Arlington County Historical Affairs and Landmark Review Board
Design Review Committee Meeting, 6 December 2023

REQUESTED REVISIONS TO HALRB CERTIFICATE OF APPROPRIATENESS
17 March 2021, Case 19-27A (HPCA21-00007)

WALKER CHAPEL HISTORIC CEMETERY PROJECT (HCP)

CoA REVISION REQUEST No. 1:
RE-INSTALLATION OF SITE ELECTRICAL EQUIPMENT

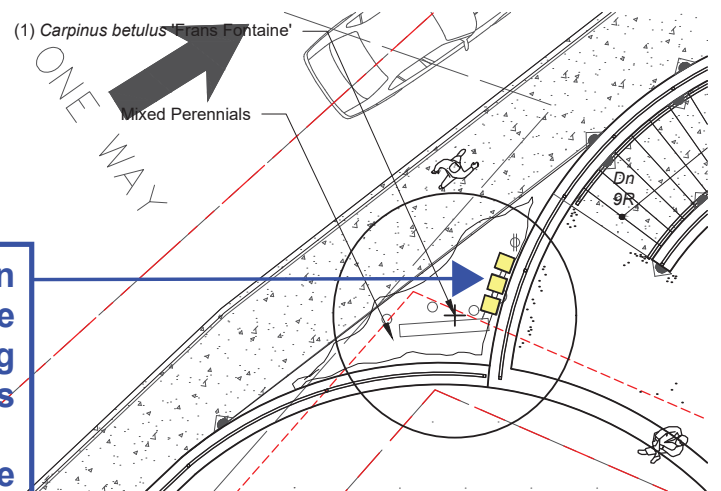
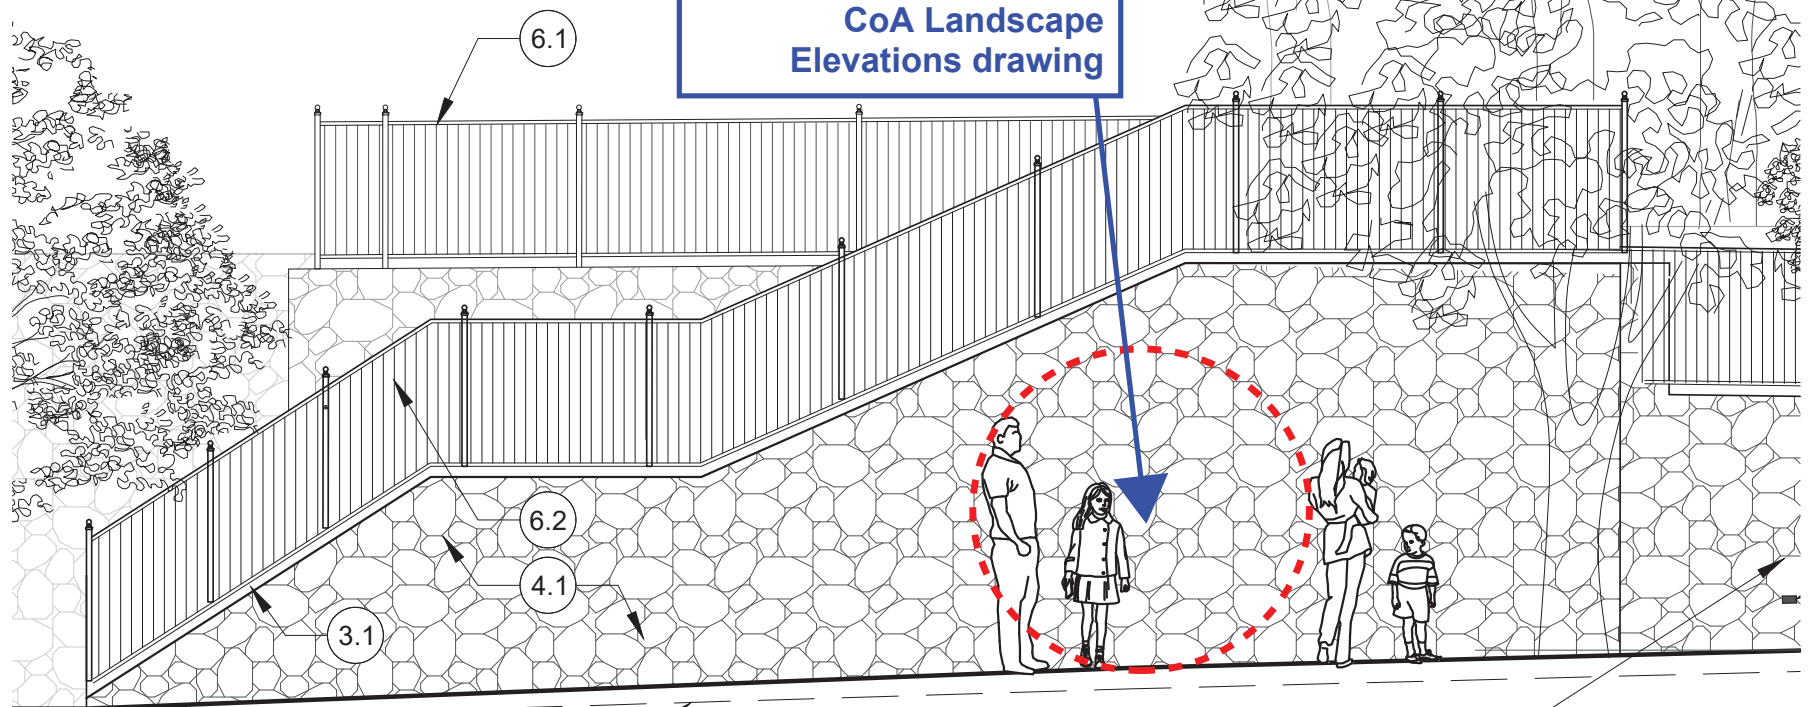
The re-installation of 100-amp electrical service panels and meter serving existing parking lot lighting and new retaining wall lighting was evaluated once construction of the new retaining wall and new driveway sidewalk (to the point of the underground electrical service) were both complete.

In dealing with as-built conditions, it became apparent that surface-mounting the panels to the curved portions of the new stone wall in an orderly fashion would be difficult due to the natural deviations in the stone wall surface, as both the wall surface geometry and the joints between stones were irregular by design. Concerns also grew about the limitations the wall-mounted electrical service equipment would impose on future wall maintenance, as periodically the stone joints will require re-pointing in order to maintain the long term integrity of the wall. Installing the equipment on a freestanding support frame as shown on the Civil drawings (see the next page) would address these difficulties and provide the opportunity to separate incoming and outgoing distribution conduits from below and from the rear of the electrical meter enclosure box and the power distribution panel.

Despite the plan note (which conflicted with the Civil drawings), there was no indication of re-installed site electrical panels on the CoA Landscape Elevations drawing

As shown on the Civil drawings, the Owner Construction Phase Representative approved installation of the electrical service equipment on a freestanding support frame permitting continuity of maintenance access to the new stone retaining wall. The as yet-unconnected electrical service equipment is mounted on a frame consisting of narrow, premium quality stainless steel channels. The electrical service panels are either stainless steel or soft-gray factory painted metal, and the flexible and rigid conduits from the panels to the underground conduits are also gray in color. The image below is a detail from the Civil drawings showing that the electrical equipment was installed as indicated on these plans.

VIEWS OF AS-CONSTRUCTED CONDITION

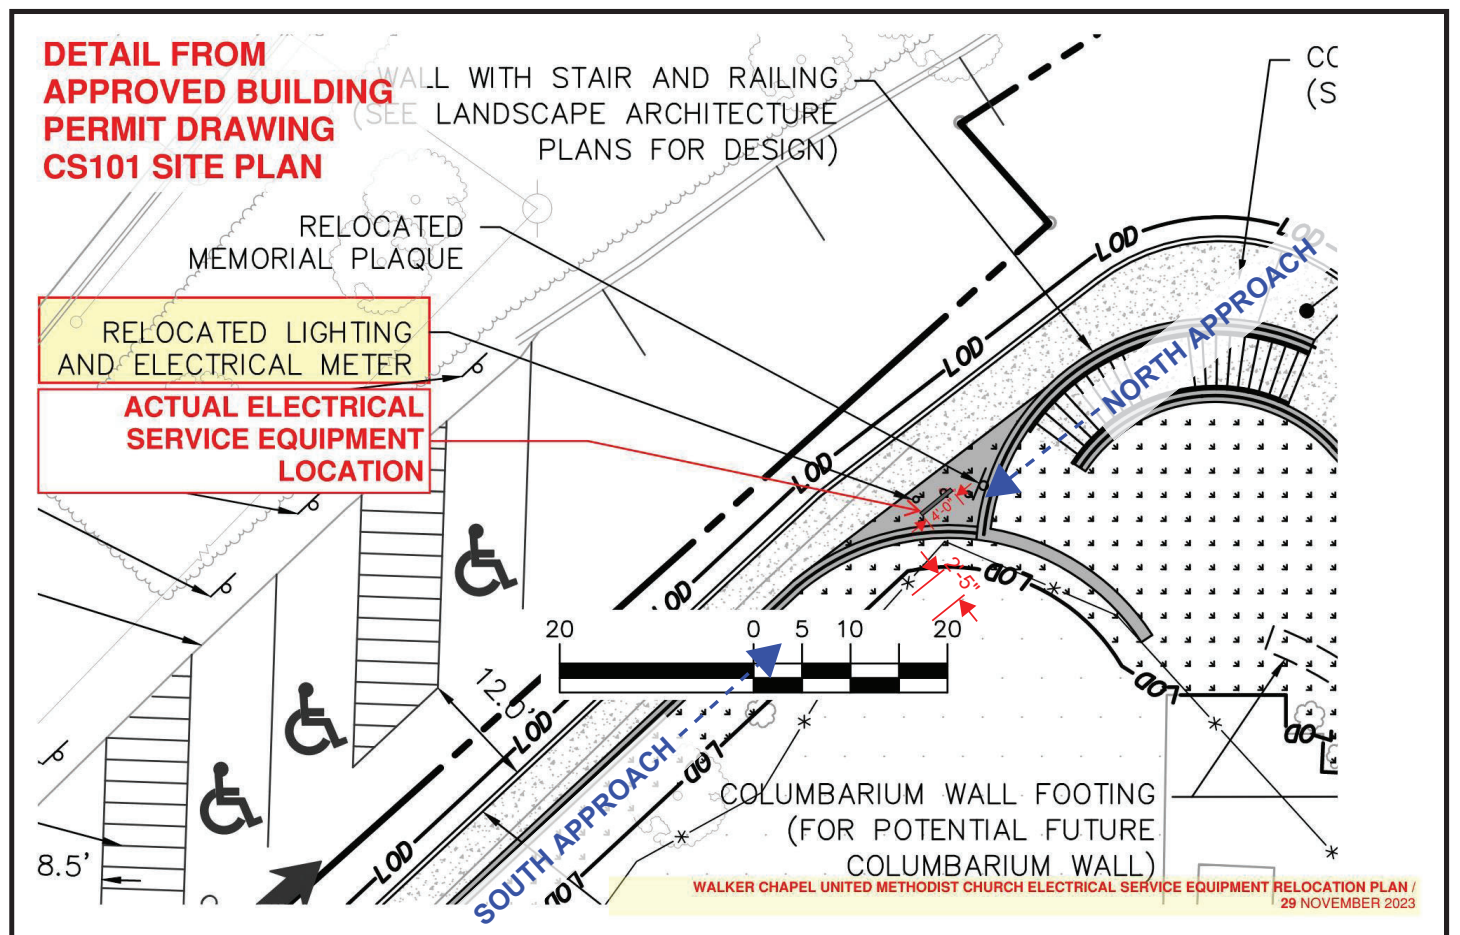
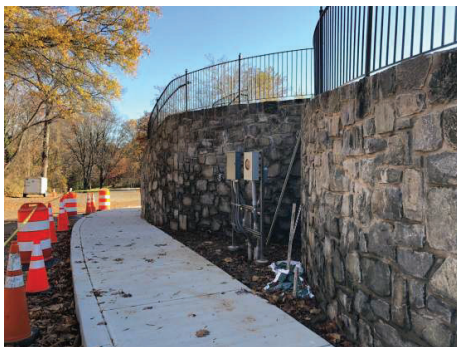
The freestanding frame allows for panels to be mounted on both sides of the frame and more importantly, allows for best-practice separation of incoming and outgoing power feeds (more than one panel box surface is used).

The main circuit breaker box (shown in the image to the left) is located on back side of frame with back feeds to both the meter box and the distribution panel box.

The new equipment is functionally the same (or similar) as the original equipment. The physical difference is that the new equipment meets current code and power company requirements, and is of commercial quality. In addition to the meter cabinet and the power distribution panel box, there will be a small, stainless steel low-voltage transformer cabinet and a digital timer cabinet controlling operation of the parking lot lights and the wall and step lights. Unlike the original installation, there is now a fourth component--the main power feed shut-off switch box referenced above.

We propose **three ways** forward pertaining to this portion of the project, two of which suggest how the existing condition could be maintained but modified in order to partially conceal and draw visual attention from the electrical distribution equipment.

OPTION 1. Procure and position manufactured privacy screen plant boxes set on stone mulch in the 2'-5" area in front of the service panel installation. The "Wallowa Metallic Heavy Planters" are not fixed; they can be moved for major-task electrical service access.

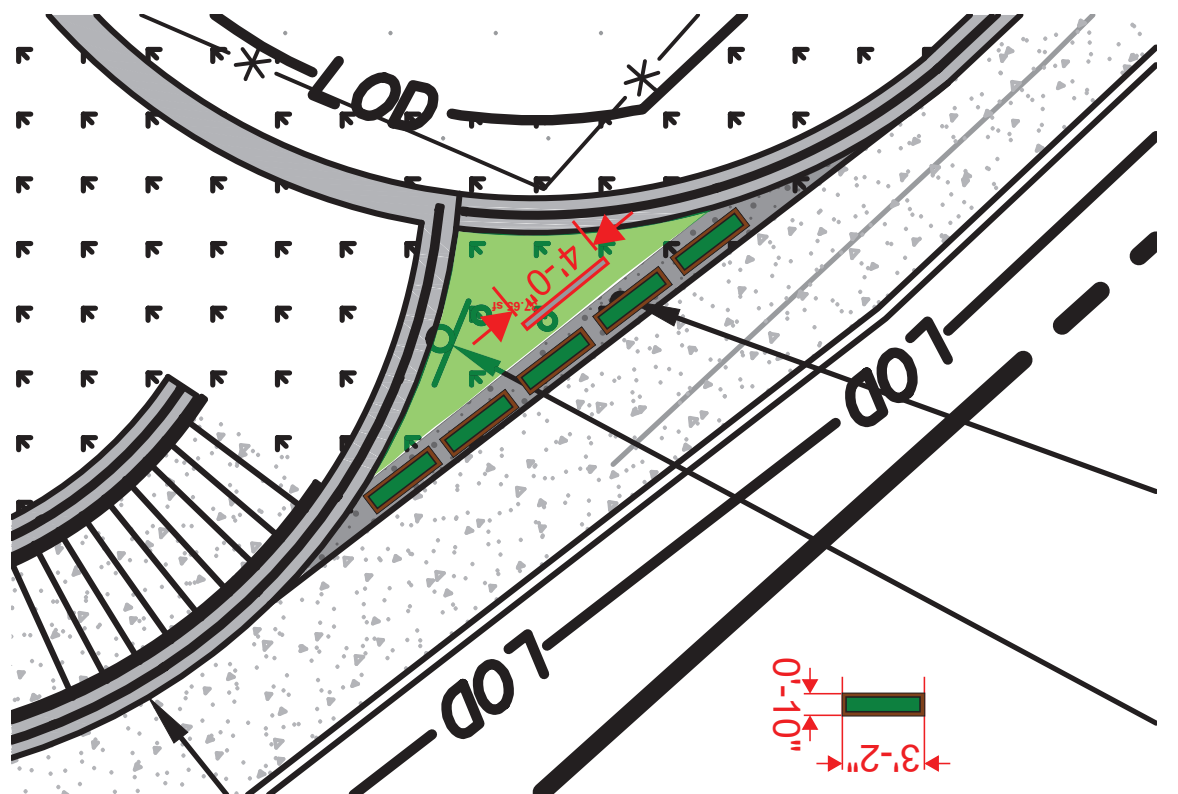
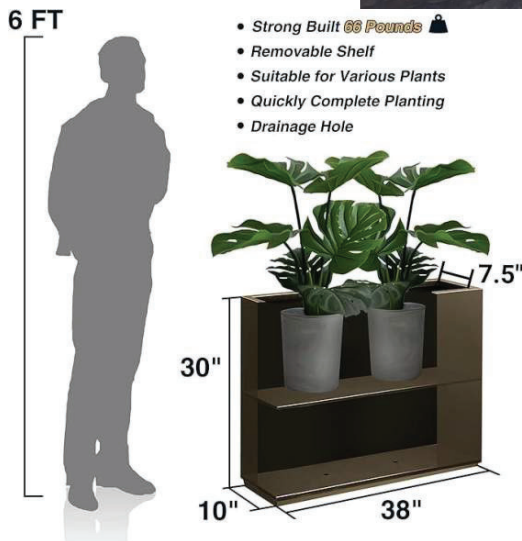
The metal cabinets are available in four colors: coffee (shown); black; gray; and white.

A variant of this approach would be a series of small, elevated planters creating a less formal, linear "potscape" as the sidewalk edge.

OPTION 2. Approach the current situation as an opportunity to create a meaningful visual "event" along the new driveway sidewalk linking the church and its parking lot.

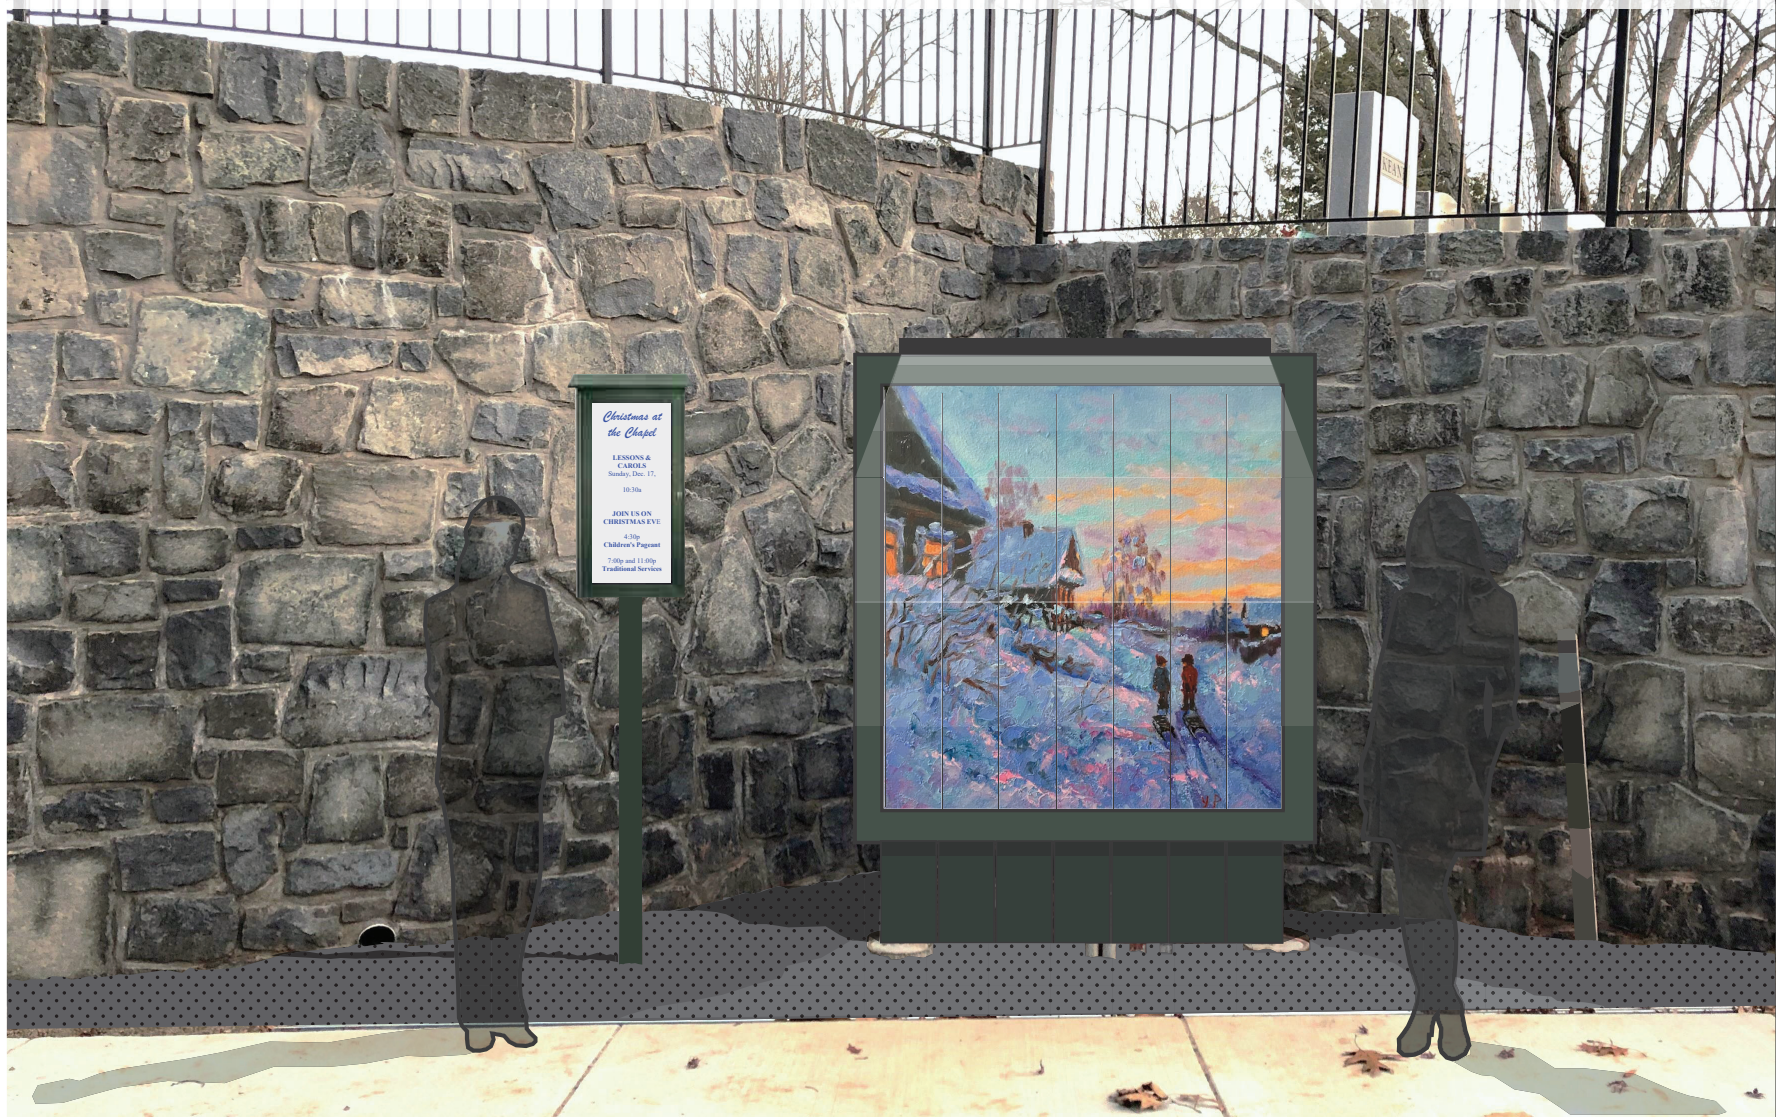
Conceal the as-constructed electrical equipment frame with a lightweight, non-conductive display frame using fiberglass channels and PVC finish boards and panels. This gravity load of the display frame would be carried by the electrical equipment frame and would not touch the ground, allowing the display frame to act as a floating visual element against the natural stone backdrop of the retaining wall. The display frame would only conceal the electrical equipment frame, and not hinder access to the electrical service cabinets.

Linear LED art lighting will be attached to the top of the display frame. Hanging from inside the head of the display frame will be changeable, printed PVC mesh fabric. Just below the attachment head, the fabric will be cut in strips to allow for access to the electrical equipment; each display strip will have weighted ends to minimize wind-driven fluttering. The church will stock a minimum of four display hangings with graphics depicting the four seasons (or different church seasons). This will also serve as an opportunity to share banner graphics of church and community events, including the work of groups using church facilities such as the McLean Art Society and the Walker Chapel Preschool. It could also be used to hang banners promoting musical concerts and other scheduled community events occurring at Walker Chapel. A PVC panel skirt will be fixed to the base of the support frame, turning the corners at both side edges to conceal conduits.

Additionally, this proposal would include the installation of a second freestanding element, a manufactured outdoor message center as suggested below. This might be an all-weather way to offer leaflets or other publications to passersby.

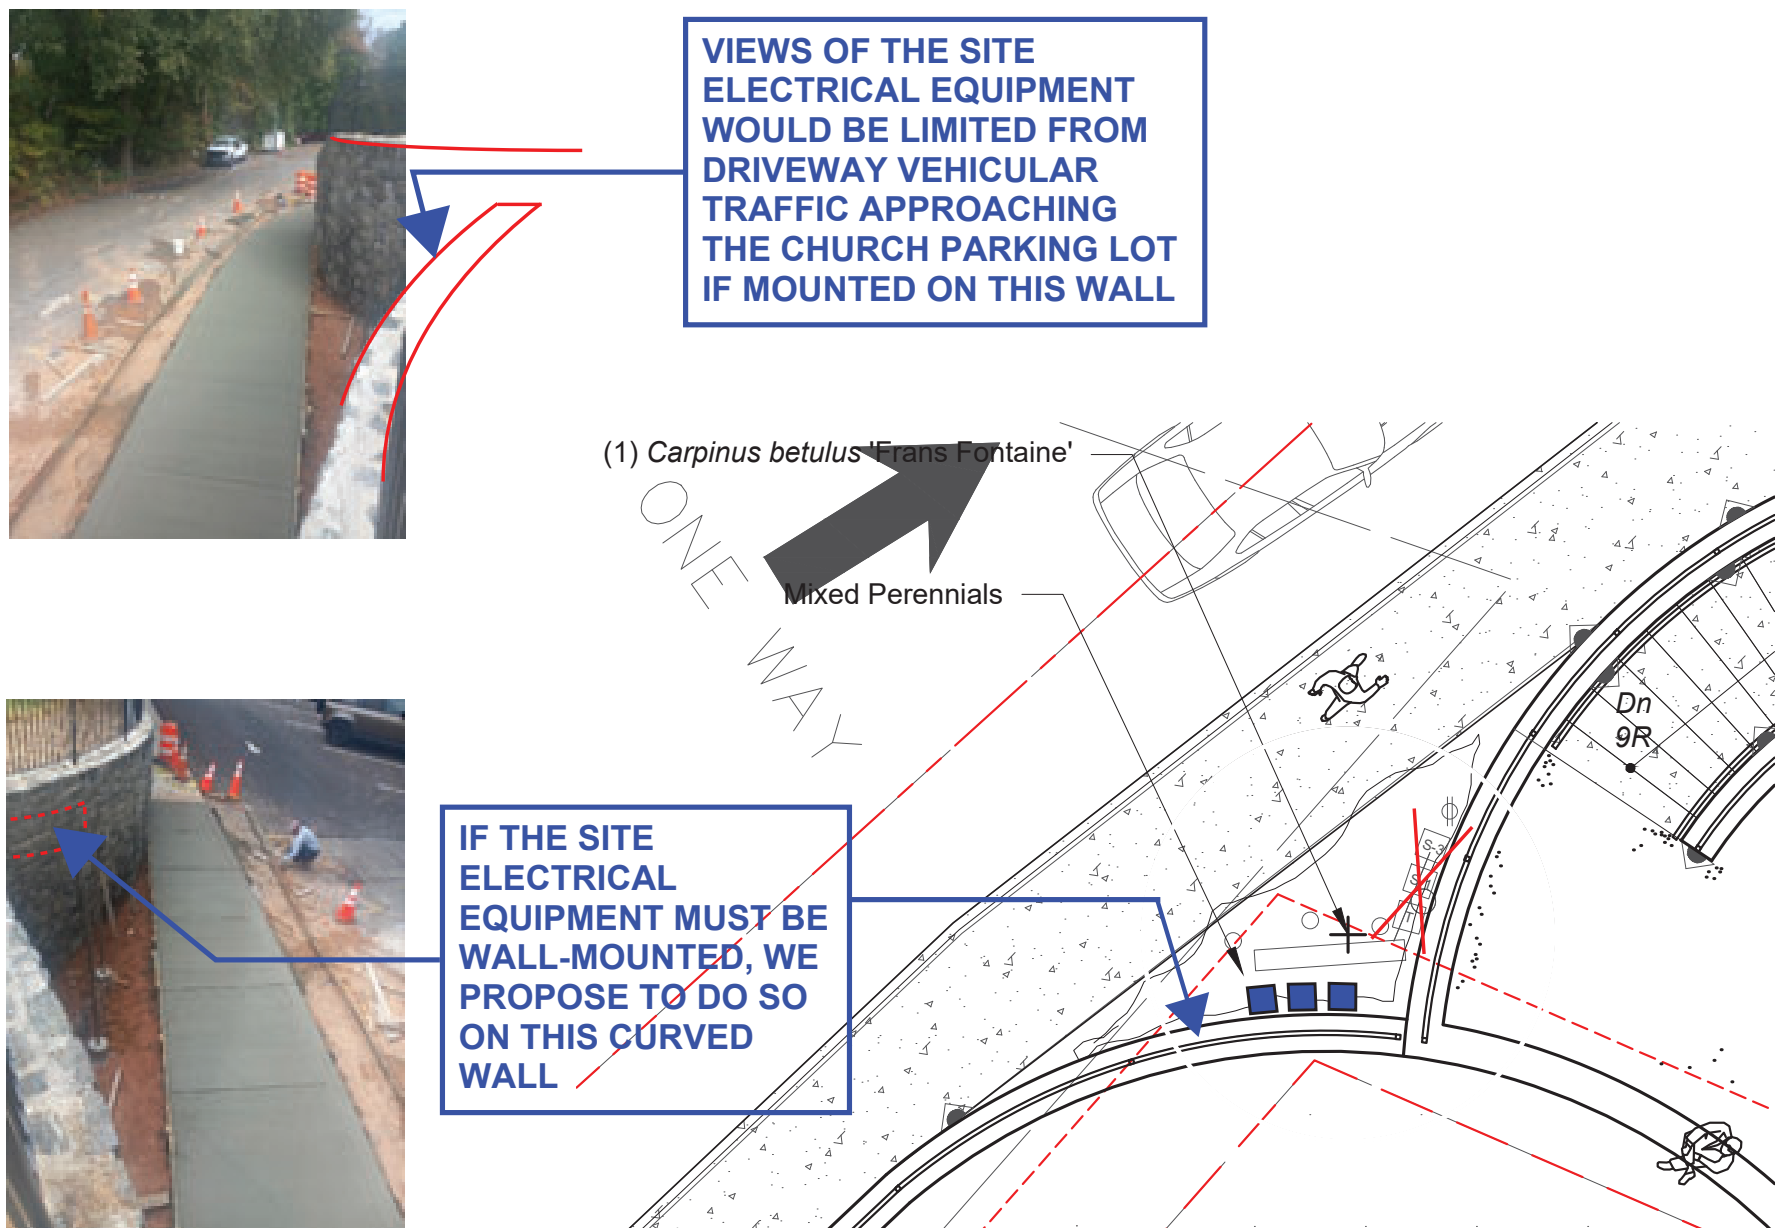
This means the freestanding service panel rack will be removed and the service panel components will be attached to supporting channels behind the equipment. The conduit-enclosed circuits, both incoming from Dominion Energy and distribution circuits into the cemetery, will be moved so that they terminate in ground-level junction boxes. The wall-mounted components will then be re-connected to their circuits within the junction boxes.

The graphic below shows the proposed location of the wall-mounted equipment components. This location is proposed because the driveway vehicular traffic flow is from left to right in the plan image; by placing the electrical equipment on the cemetery wall rather than the staircase wall, views of the equipment are better blocked. Once installed, consideration will be given to using plants to further obscure the equipment from view.

While this approach may result in the least visual awareness of the site electrical equipment, it will be the most expensive option to implement. As for maintaining the integrity of the new retaining wall and preserving the sanctity of the cemetery, there is a difference of opinion amongst church leaders; some feel that the site electrical equipment is best handled as a freestanding but screened element not touching the historic cemetery and others who feel that the wall-mounted option is more appropriate.
